HISTORIC PRESERVATION COMMISSION

TO: Rabbiah Sabbakahn
Department of Permitting Services
FROM: Rebecca Ballo
Historic Preservation Section
Maryland-National Capital Park & Planning Commission Historic Area
SUBJECT: Work Permit #1029631- After the fact demolition of the garage and construction of a new garage

MONTGOMERY COUNTY HISTORIC PRESERVATION COMMISSION
STAFF REPORT

Address:	10221 Montgomery Avenue, Kensington	Meeting Date:	9/6/2023
Resource:	Contributing (Primary One) Resource Kensington Historic District	Report Date:	8/30/2023
Applicant:	Bruce Caswell and Lauren Deichman (Mike Roberson/McFarland Woods, Agent)	Public Notice:	8/23/2023
Review:	HAWP	Tax Credit:	N/A
Case Number:	1029631	Staff:	Rebecca Ballo
PROPOSAL:	After the fact demolition of the garage and construction of a new garage

Sheet Title
GARAGE ELEVATIONS

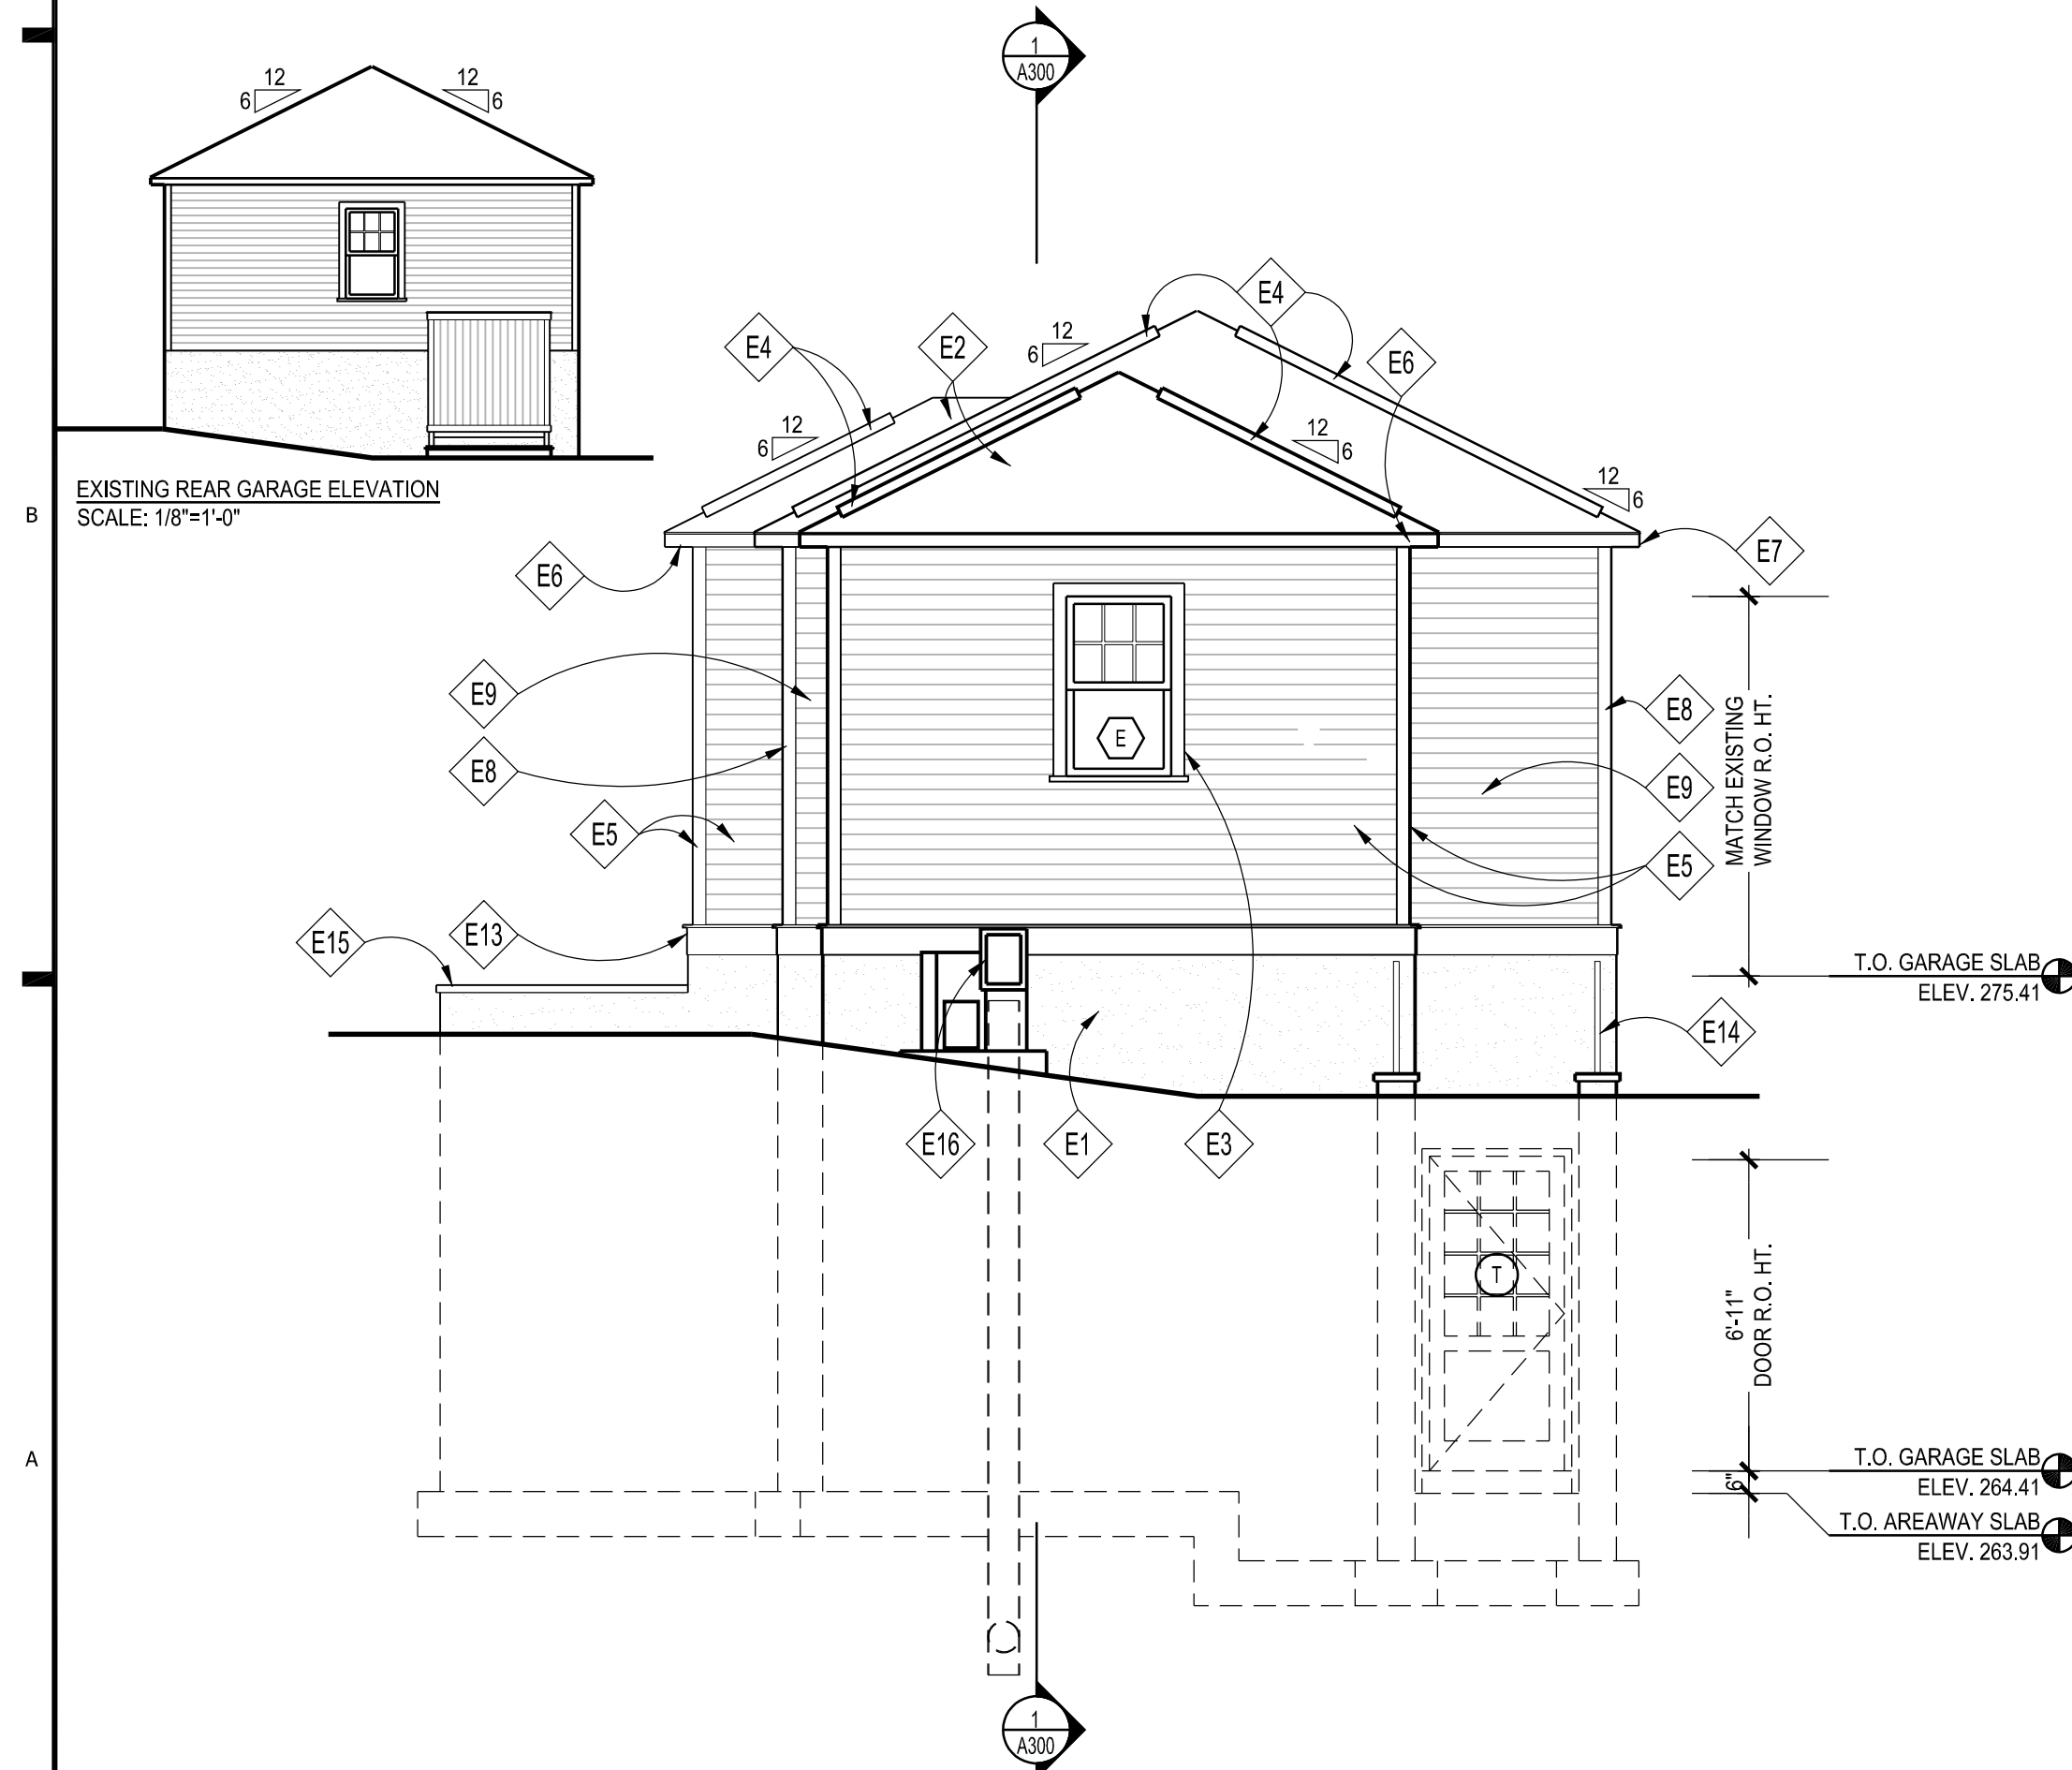
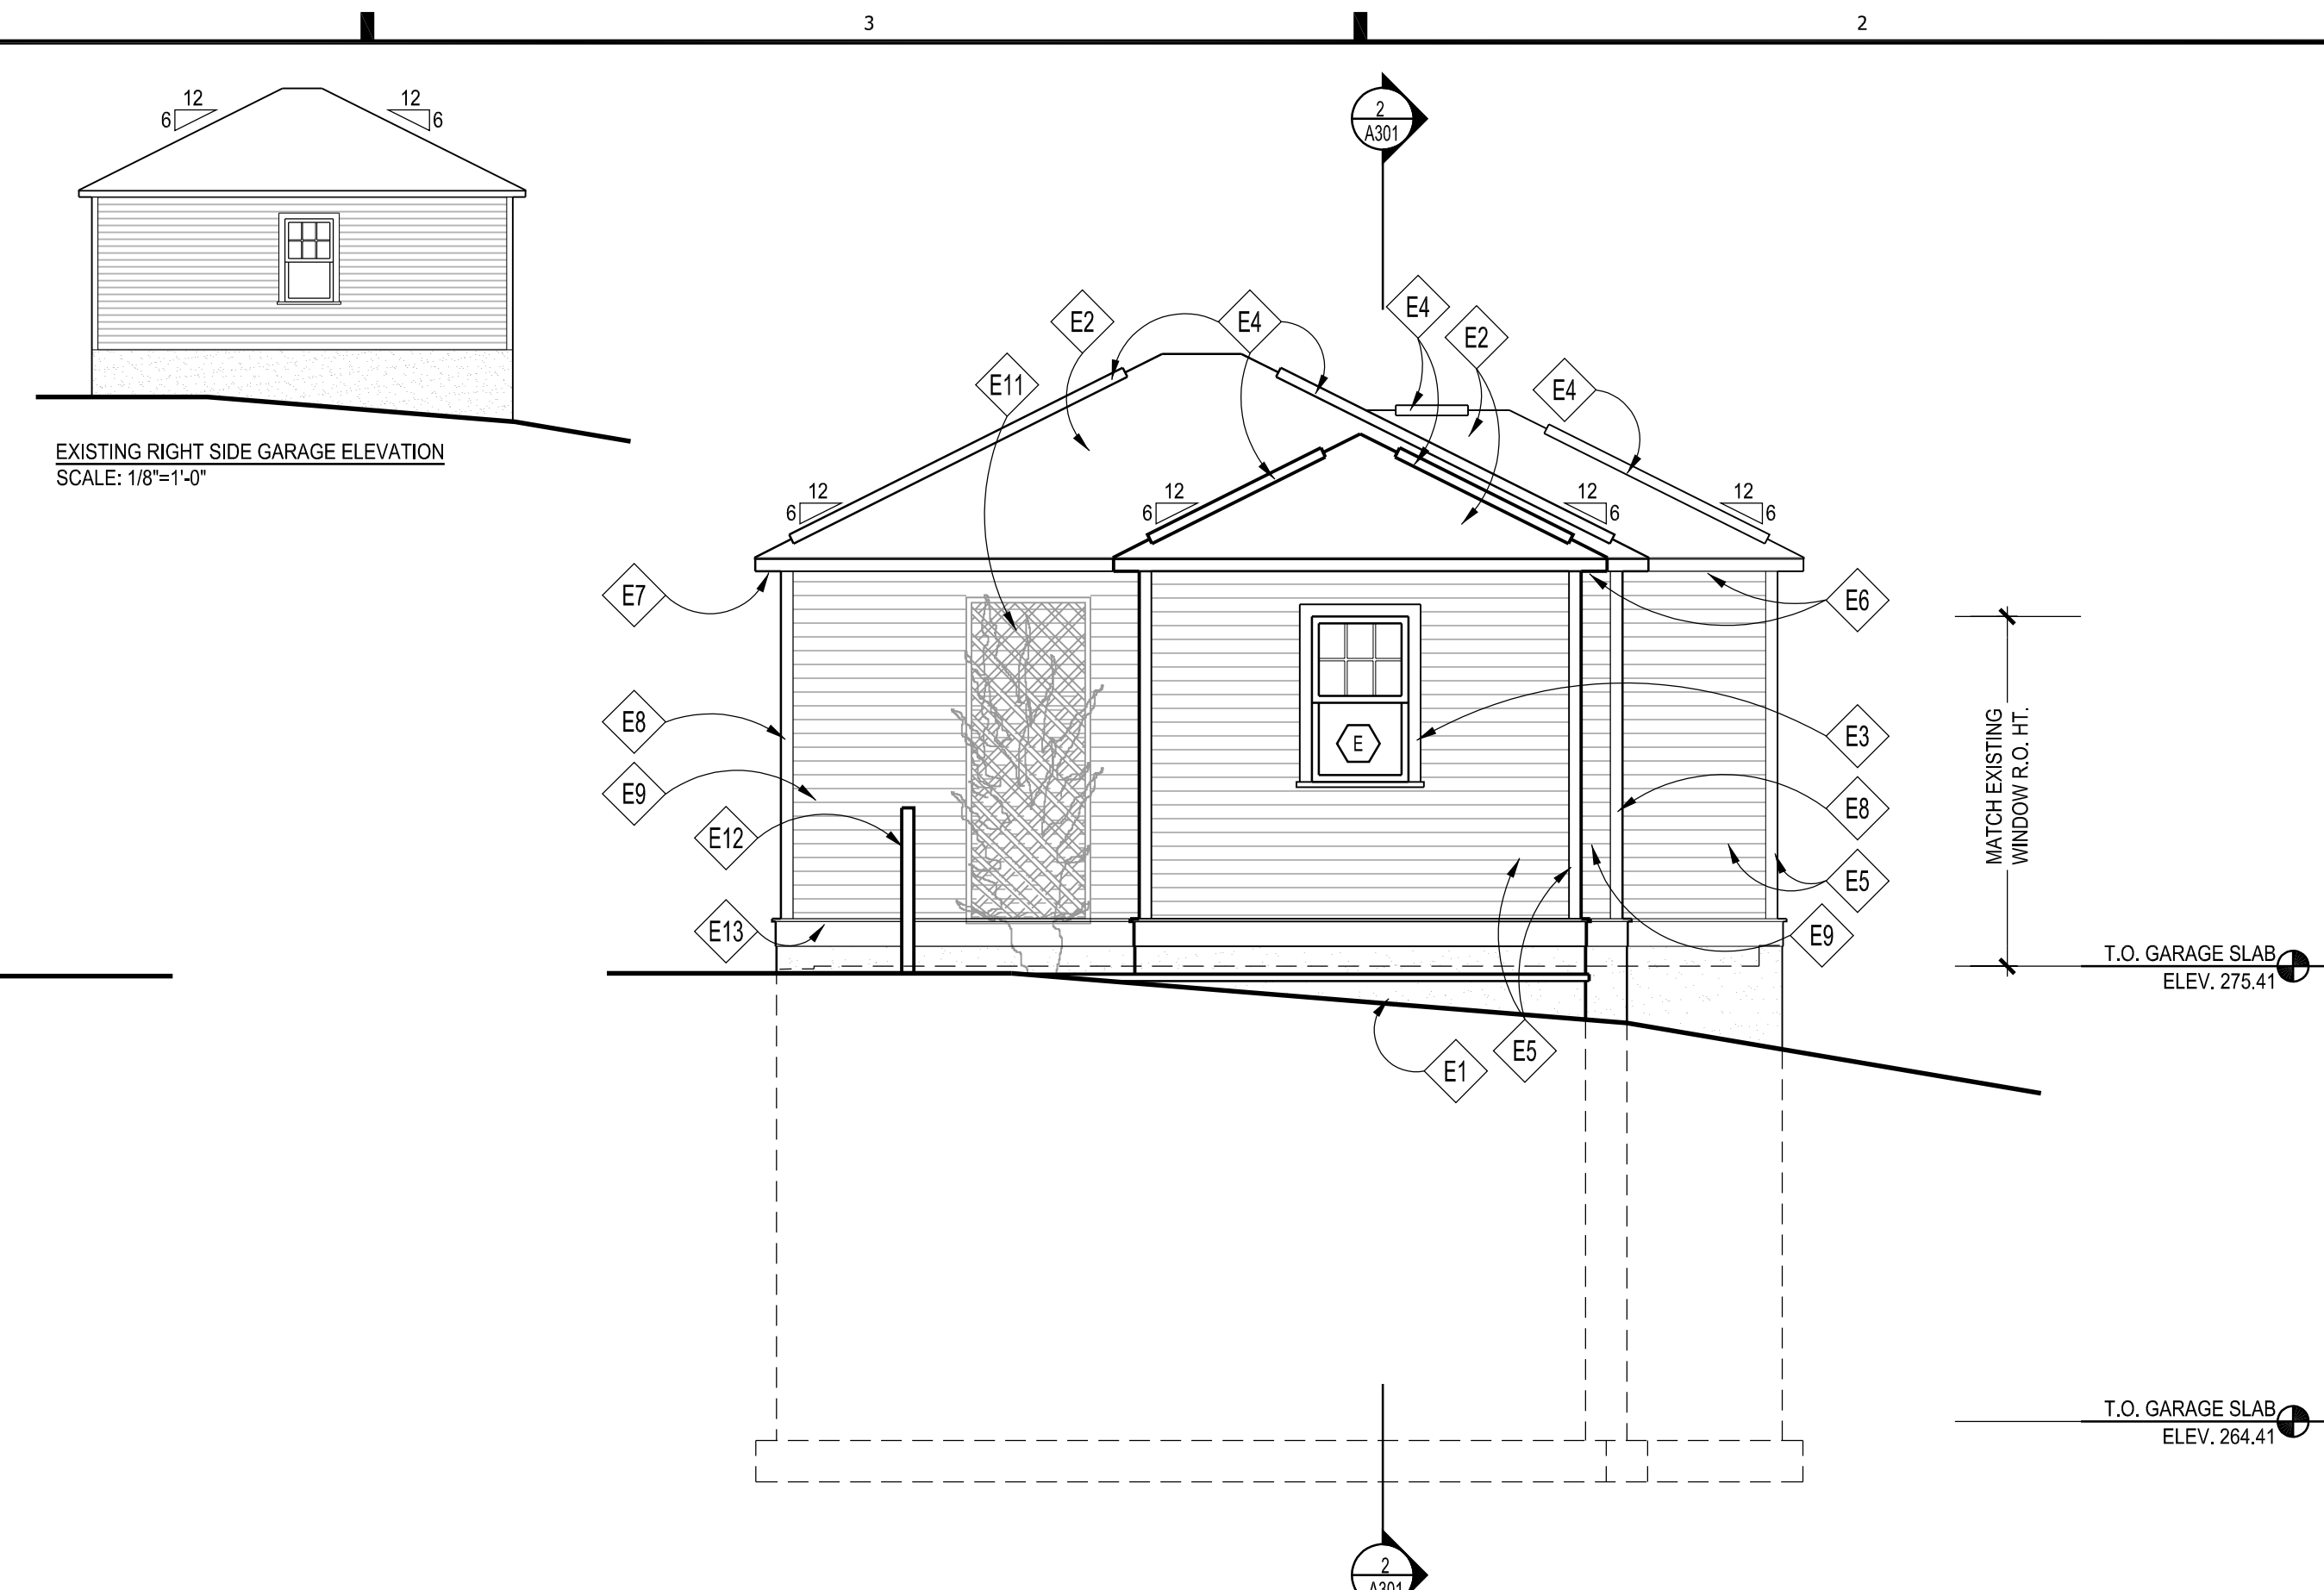
- 1) The applicant shall submit a corrected copy of the as-built drawings showing the new structure from all four elevations, in plan, and with accurate material notations, noting that this is “New Construction”;

- 2) The single hung windows shall be 6/1 to match those from the demolished garage. The windows may be wood or aluminum clad wood, with simulated-divided-lite spacers. Final details of the windows shall be shown on the revised drawings;
